Response to Submissions

Barangaroo South
Concept Plan MP06_0162 Modification 10

Submitted to Department of Planning, Industry
and Environment

17 July 2020 | 2190714

Visual impact assessment

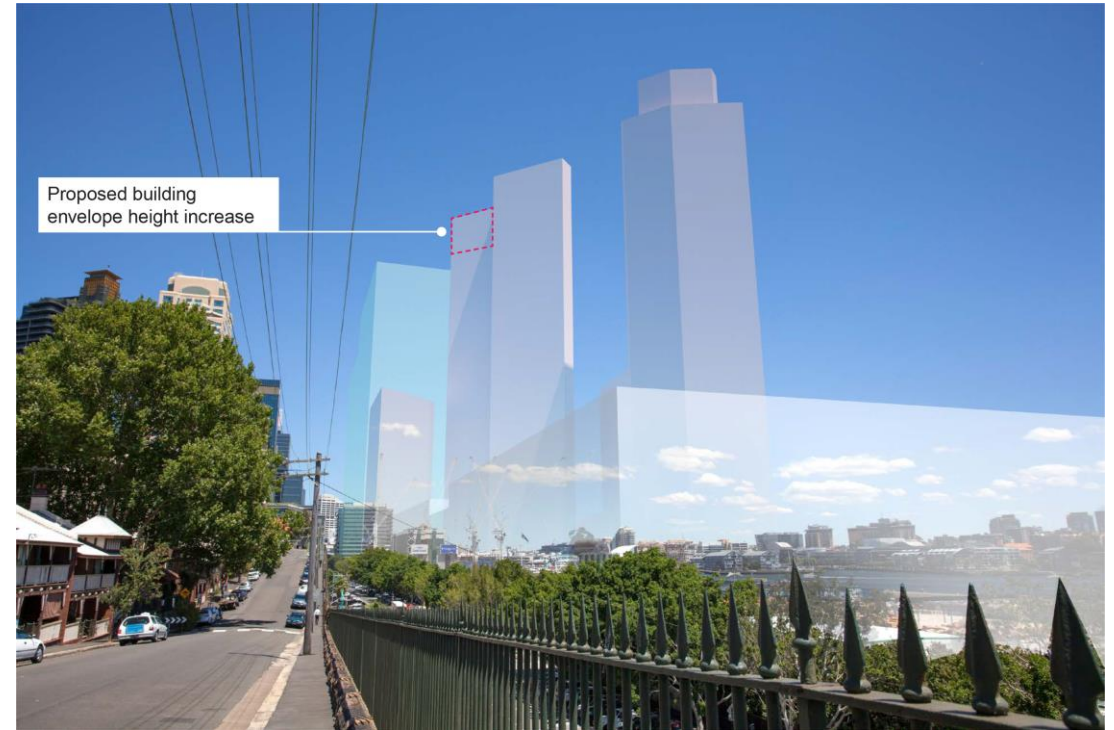
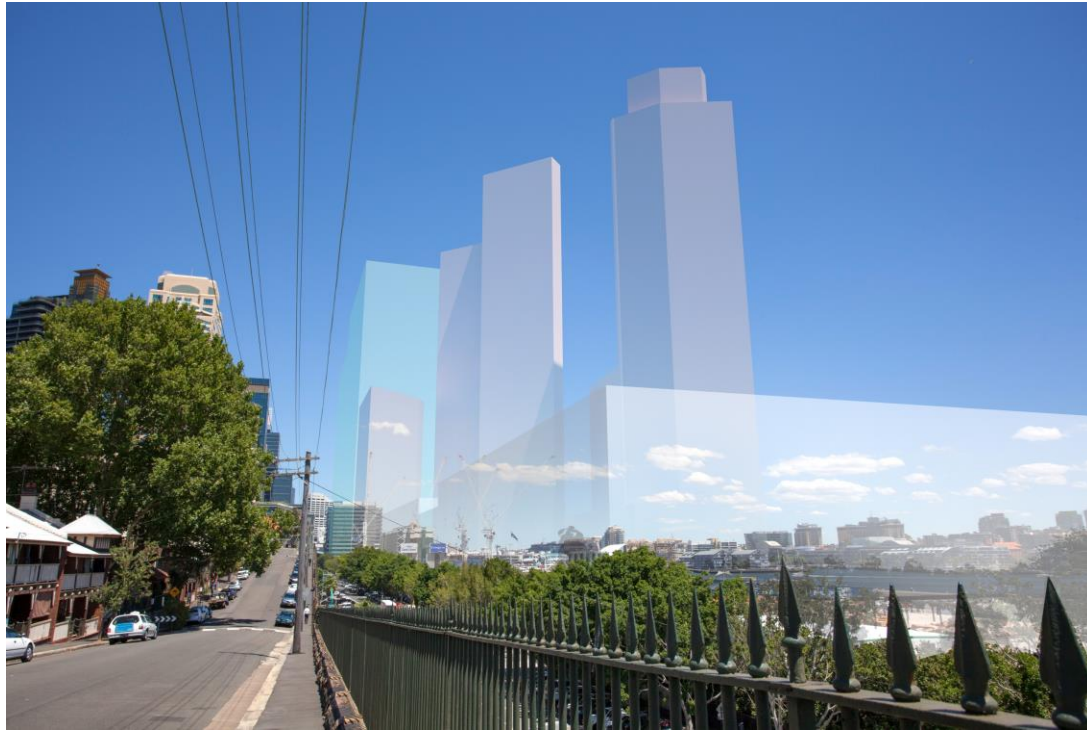
Key Issues Raised	Response
<p>Page 32 and 33 of the visual impact document incorrectly shows the impact of Mod 8 / Mod 10 - they appear swapped and therefore are misleading about the potential visual impact of the additional height.</p>	<p>A detailed response has been prepared by Virtual Ideas in relation to this comment (see Attachment E). The response confirms that the images on Page 32 and 33 of the Visual Impact Assessment are correct. For this Modification Application, the colour of the imaging was improved to enhance readability.</p>
<p>Insufficient detail has been shown regarding overshadowing and loss of solar access for Barangaroo, The Rocks, Circular Quay, etc.</p>	<p>Shadowing diagrams were produced by Virtual Ideas and compare the impact of additional shadow cast as a result of the increased height with the approved Concept Plan (MOD 8) building shadows.</p> <p>The updated shadow analysis demonstrates that the impact of the proposed R4B Building height increase does not cast significant additional overshadowing on key public domain areas, including Hickson Park. While there are minor portions of additional shadow cast, these predominantly fall on Sydney Harbour, roads or areas of the CBD already in significant shadow.</p> <p>Wulugul Walk would experience a slight increase in shadow for a short period of time only, however it is during a time when the remainder of the foreshore is in full sun.</p> <p>As there is no height increase on the Building Envelope Plan to Block 4B, no additional shadow will be cast from Building R5.</p>

We have reviewed the images presented on both the "Mod 10 Visual Impact Photomontages report dated 30th January, 2020" and the "Mod 8 Visual Impact Photomontages report dated 18th of September, 2014". Following this review we have determined that the resident making the submission is likely to be commenting on a revised visual treatment used to layer the semi-transparent massing envelopes in 'View 9 - Munn Reserve' as presented on pages 32 and 33 of the Mod 10 Photomontages report dated 30th January, 2020 (shown as an extract in Appendix D of this letter).

This visual treatment was therefore revised for the Mod 10 submission so that the envelopes could be presented in a clearer way for the reader.

Image showing massing of the Proposed Concept Plan Amendment (Mod 8)

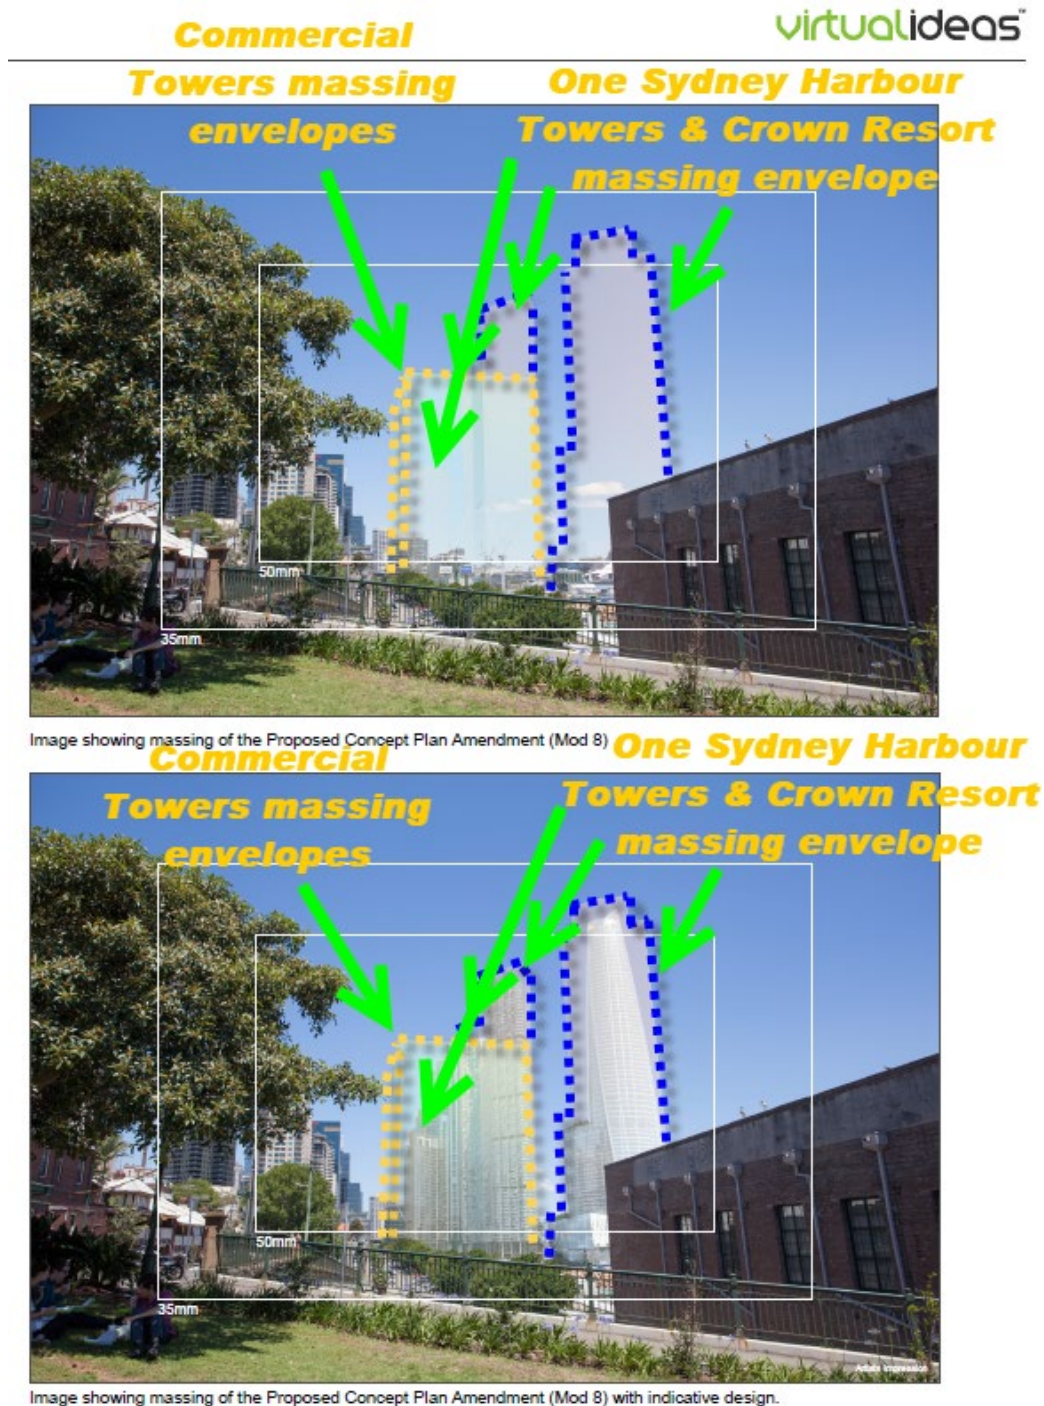
The blending of the transparent massing envelopes creates a brighter area which could give the impression that the Commercial Towers Massing Envelopes sit in front of the One Sydney Harbour Towers and Crown Resort massing envelopes from the camera perspective.

Appendix B

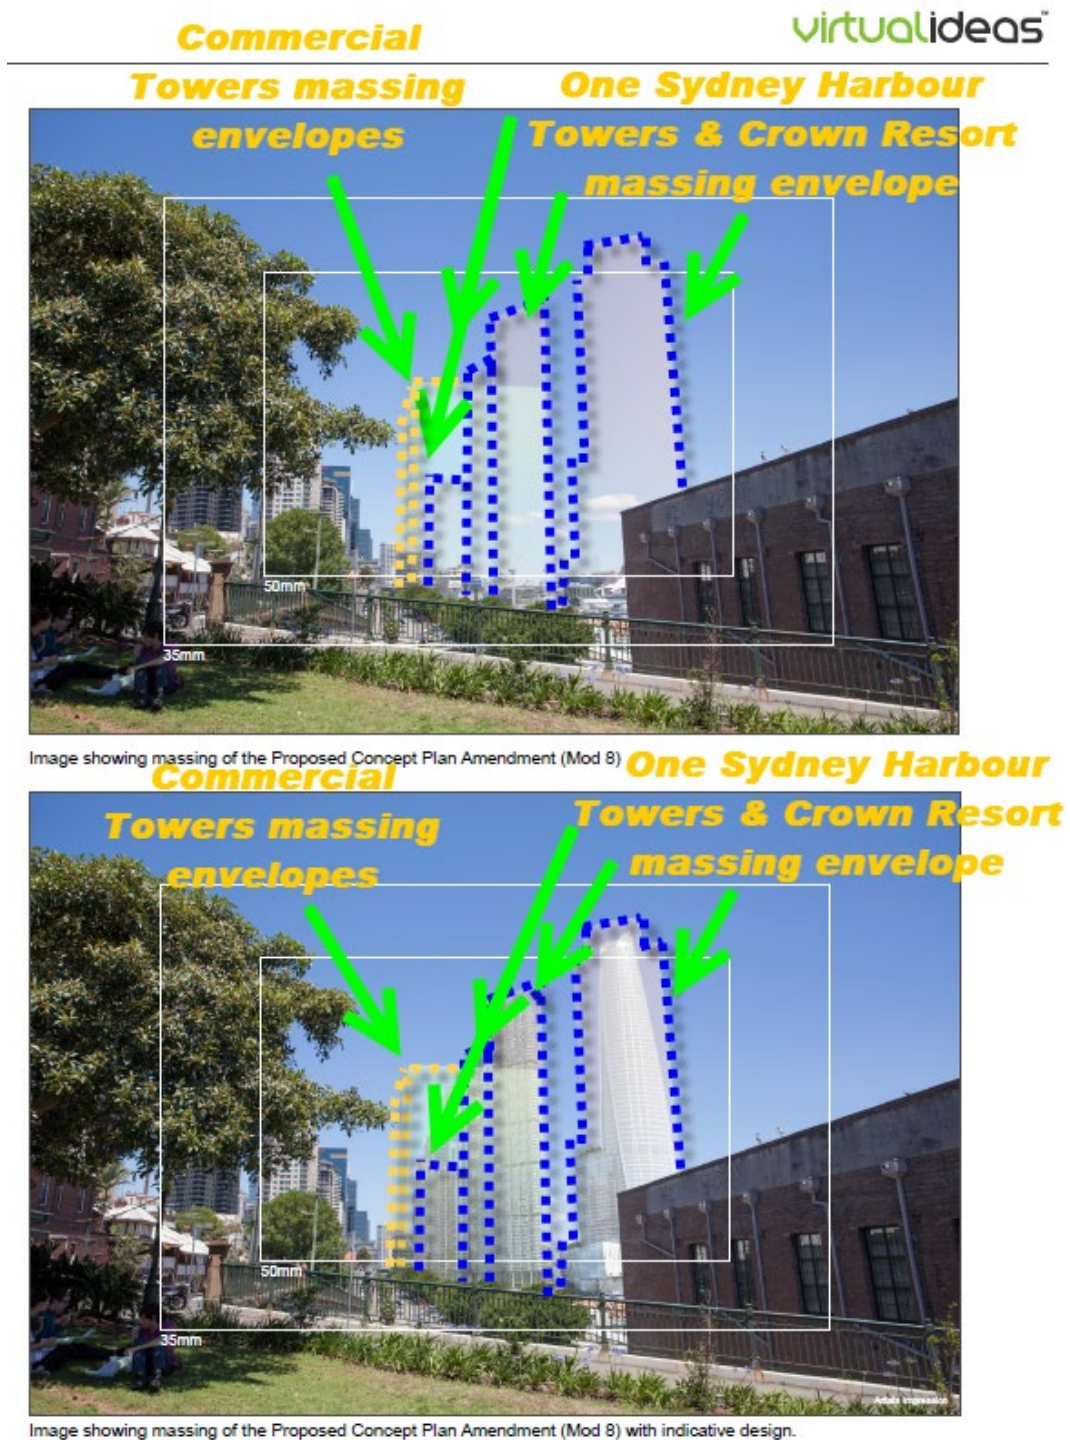
The mark-up below indicates how the overlaying of the transparent massing volumes from this camera perspective could be misinterpreted to suggest that the One Sydney Harbour Towers and Crown Resort massing envelope (the blue dotted box) sits behind the Commercial Towers massing volume (yellow dotted box).
